Office Action Summary	Application No. 10/540,398	Applicant(s) BERANGER ET AL.	
	Examiner Stephanie E. Tyler	Art Unit 3754

Detailed Action

FIG. 1

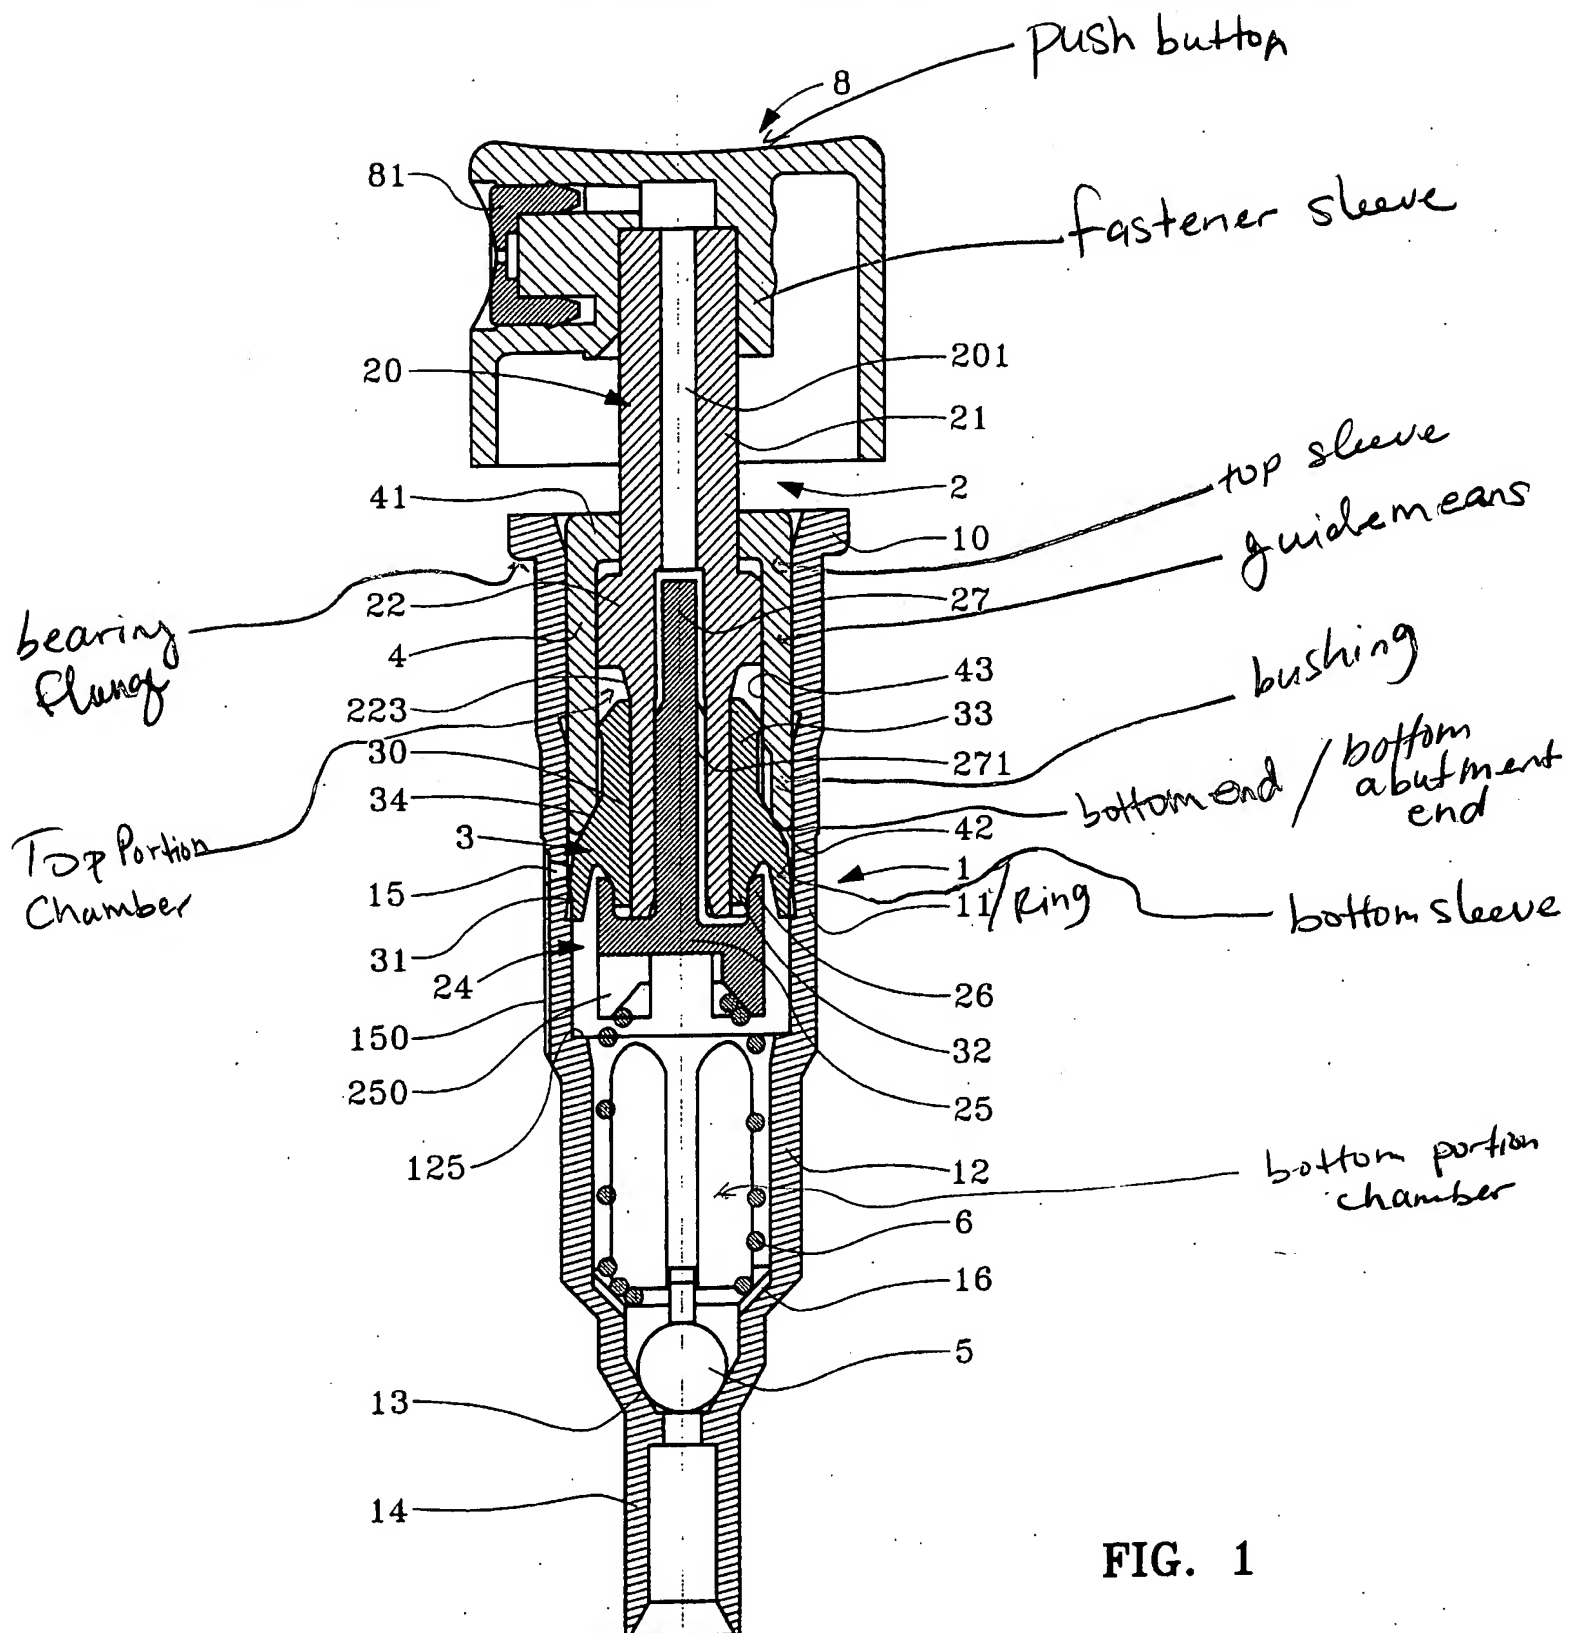
The Hermouet et al. reference discloses a fluid dispenser device (fig.1) having a chamber (fig.1)¹ provided with an inlet valve (5,13) and with an outlet valve (32), and defining a sealed slide cylinder (41); a piston (3) disposed inside the chamber and including a lip (31) capable of sliding in sealed manner in the slide cylinder (41); an

actuator rod (27) on which the piston (3) is slidably mounted; a bearing flange (fig.1) for coming to bear against a reservoir neck; and a ferrule (4) against which the piston (3) is resiliently urged in the rest position; the device being characterized in that the chamber comprises a top portion (fig.1) and a bottom portion (fig.1), the sealed slide cylinder (41) being situated above the bearing flange (fig.1), at the top portion, so that it cannot be inserted into a reservoir neck, and in that the bottom portion (fig.1) is situated below the flange (fig.1), so as to be inserted into the reservoir neck.

Re: claim 2 the slide cylinder (41) defines a bottom abutment end (fig.1) situated substantially at the bearing flange (fig.1).

Re: claim 3 the piston (3) is provided with guide means (fig.1) for holding it on the axis inside the chamber.

Re: claim 4 the guide means (fig.1) include a top guide sleeve (fig.1) engaged in a through hole formed by the ferrule (4).

Re: claim 5 rod (27) is not in contact with the ferrule (4).

Re: claim 6 the top sleeve (fig.1) surrounds the actuator rod (27).

Re: claim 7 the guide means include a bottom guide sleeve (fig.1) engaged in a bushing (fig.1) defining a bottom portion (fig.1) of the chamber.

Re: claim 8 the bushing (fig.1) defines a bottom end (fig.1) serving as an abutment for the inlet valve (5) in the open position.

Re: claim 9 a precompression spring (16), situated outside the chamber (fig.1), bears between the rod (27) and the piston (3) so as to urge the outlet valve (26,32) into the closed position.

Re: claim 11 the slide cylinder (41) is formed by a body, the bearing flange (fig.1) being formed by a ring (fig.1,11) engaged around the body (1).

Re: claim 12 a pushbutton (8,fig.1) forming a fastener sleeve (fig.1), the actuator rod (27) defining a housing, the sleeve being engaged in the housing².

Re: claim 13 a vent passage (15) that is closed in the rest position by a cone-shaped sealing contact.
